MIDLAND PLANT  
CONSUMERS POWER COMPANY  
JOB NO. 7220

SOILS INVESTIGATION  
AND  
TESTING REQUIREMENTS

Addendum No. 2

Subject Consumers Power Company  
Midland Plant Units 1 and 2  
Job 7220-001  
Cooling Pond Dikes From H. H. Burke

Figure 1

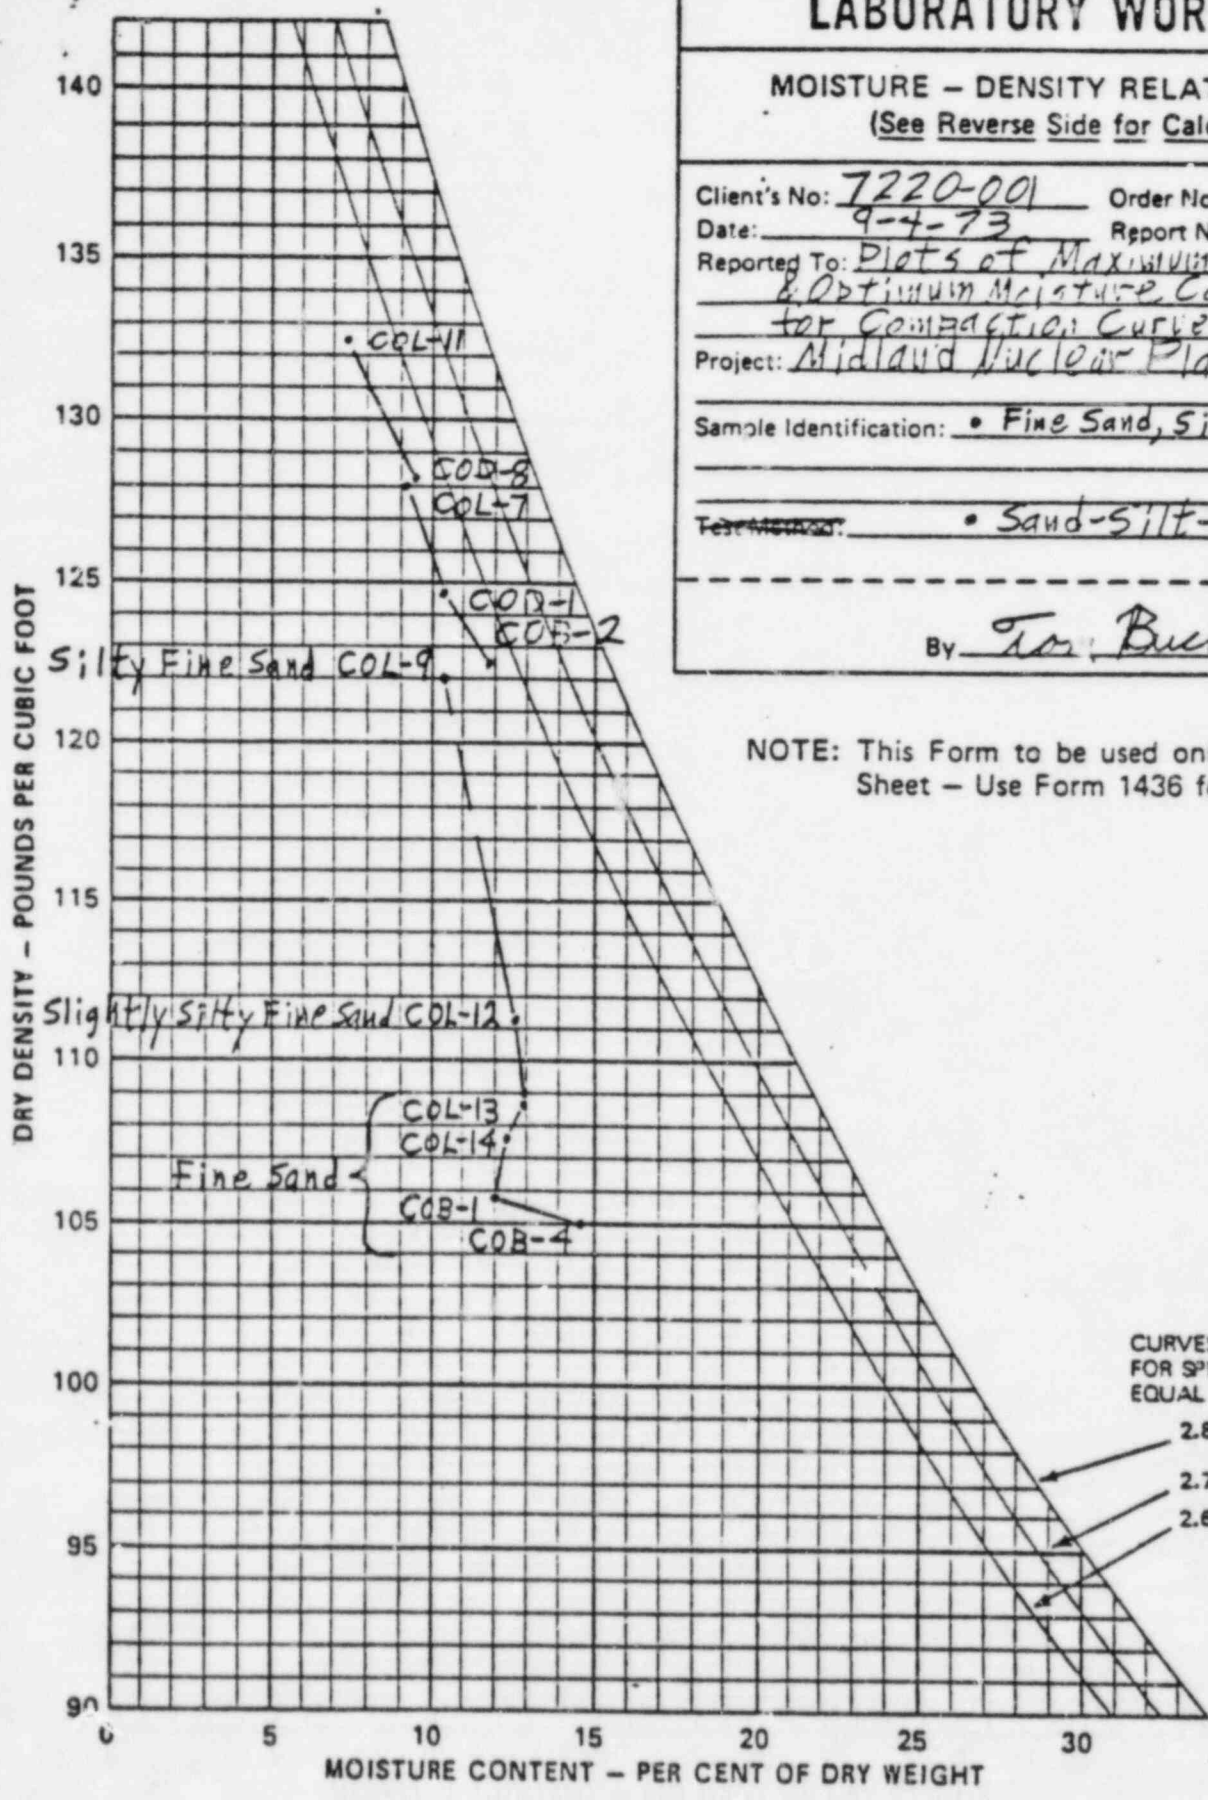
Figure 1 shows the plot of the peaks of all curves at each Maximum Dry Density (MDD) and Optimum Moisture Content (OMC). The figure shows an individual trend for each family which is shown in a different color. All four families merge at an MDD of 122 pcf and an OMC of 11%.

FOUNDATION LOCATION PLAN  
ADMINISTRATION BUILDING  
MIDLAND NUCLEAR UNITS 1 & 2

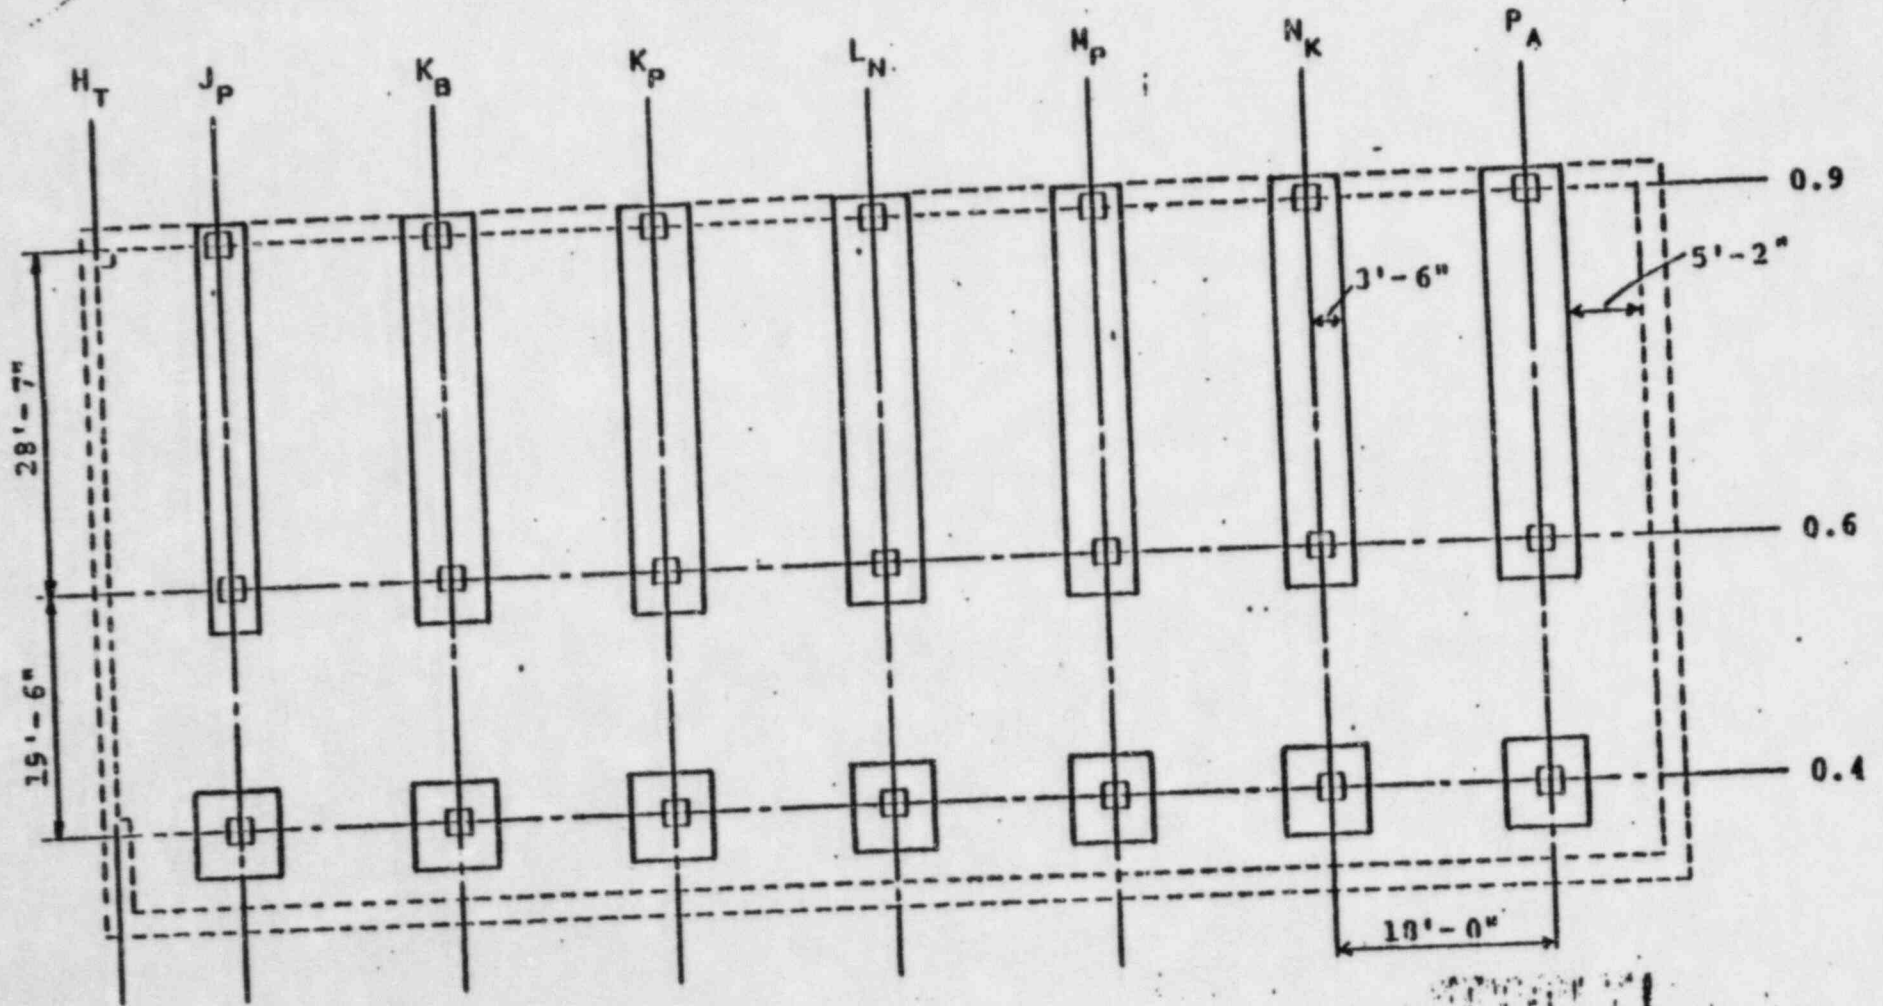
Early in September, 1977, we were requested by project engineering to assist in reviewing conditions surrounding footing settlements during construction of the Midland Project Administration Building. The foundation location plan for this building is shown in Figure 1. The affected foundations are those along Column Line 0.4.
